**Subject: Alleged "Structural Protection" of Jeep Grand Cherokee Fuel Tank System**  
**Reference: EA12-005 File Update**

**Subject:       Alleged “Structural Protection” of Jeep Grand Cherokee Fuel Tank System**  
**Reference:     EA12-005**

ZJ-Body Rear Fuel Tank Fill  
Layout Underside View : fuel tank  
removed.

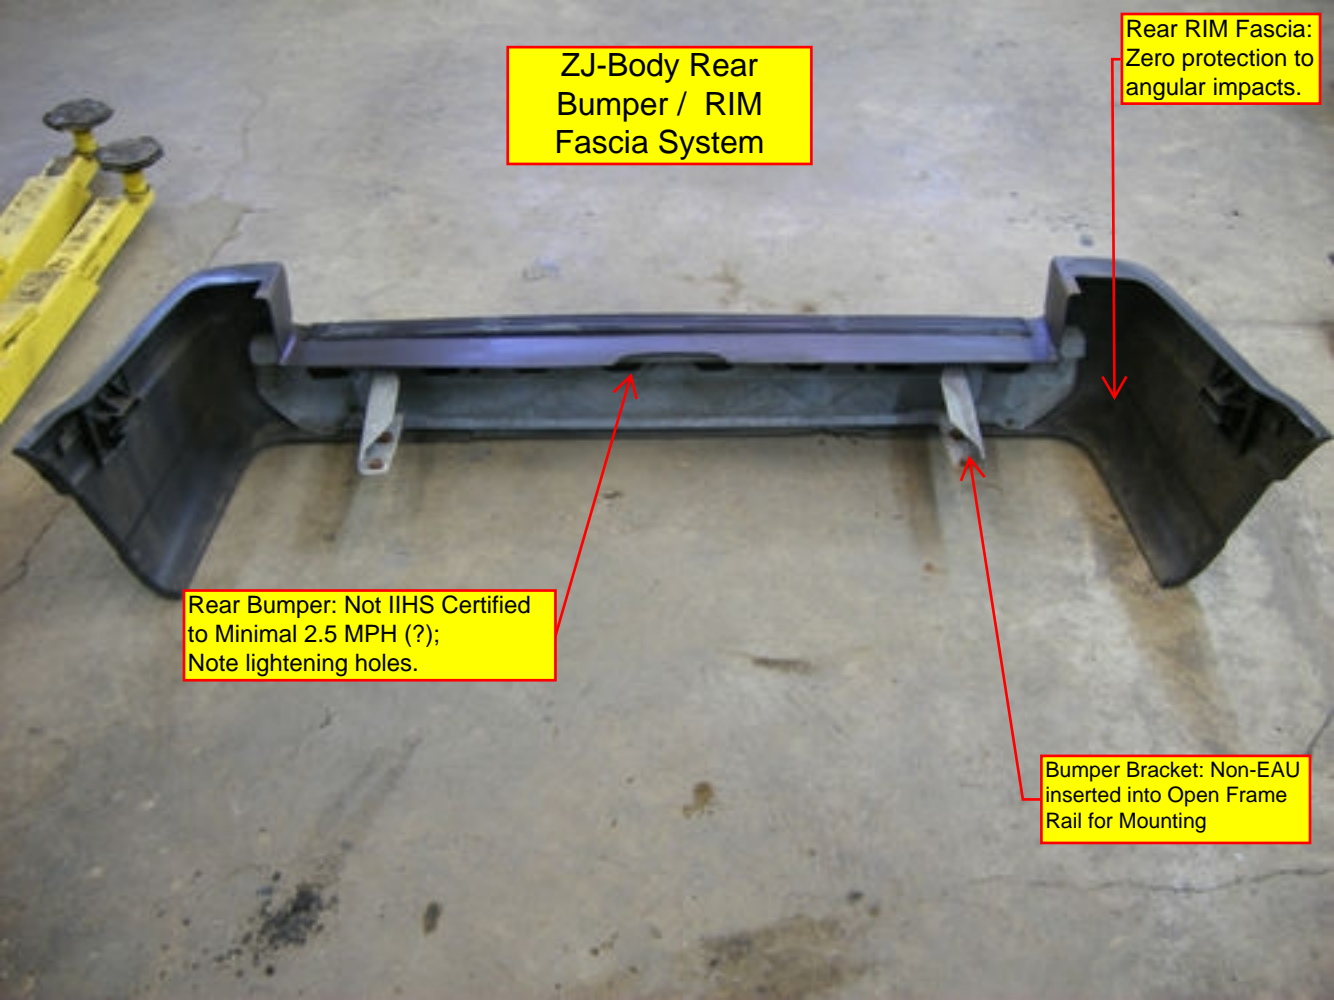
Frame Rail Hole for Fuel Tank Filler / Vent  
Hose for pass-through to Fuel Tank.

Left Side (inner surface) of Driver's Side Rear RIM Fascia.
